eGrabber

Flash EEPROM Change Note

1629 Coaxlink Duo PCIe/104-EMB
1633 Coaxlink Quad G3
1633-LH Coaxlink Quad G3 LH

Visual Identification

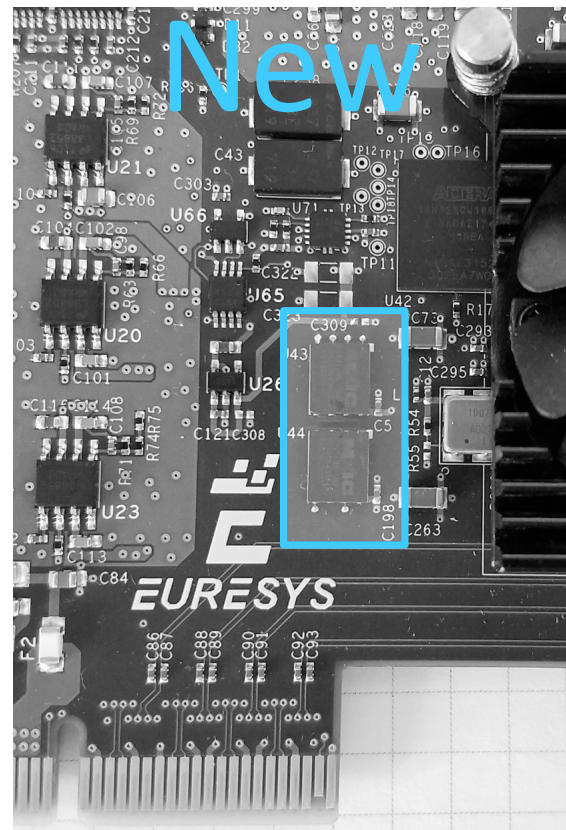
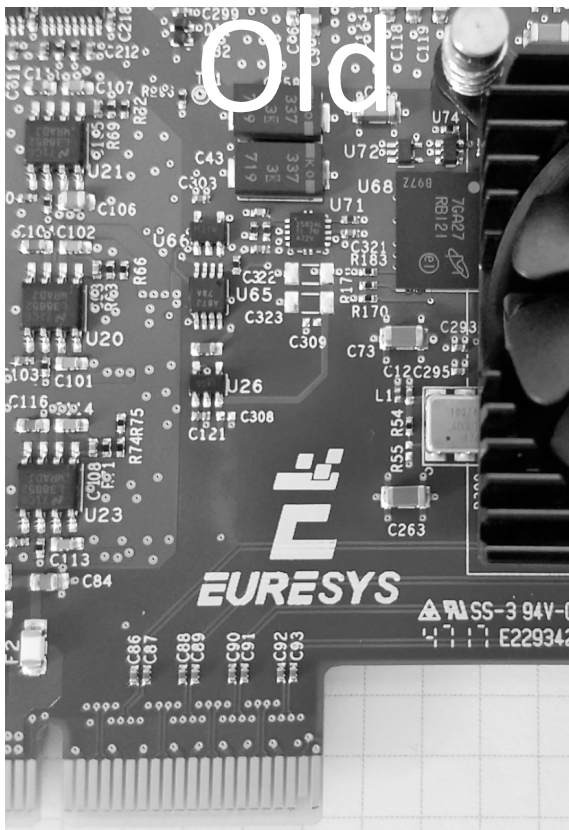
New 1633 Coaxlink Quad G3, 1633-LH Coaxlink Quad G3 LH and 1637 Coaxlink Quad 3D-LLE can be visually identified by the two SPI Flash Memory IC's located between the fan and the PCI Express connector.

See the blue rectangle in the following drawing:
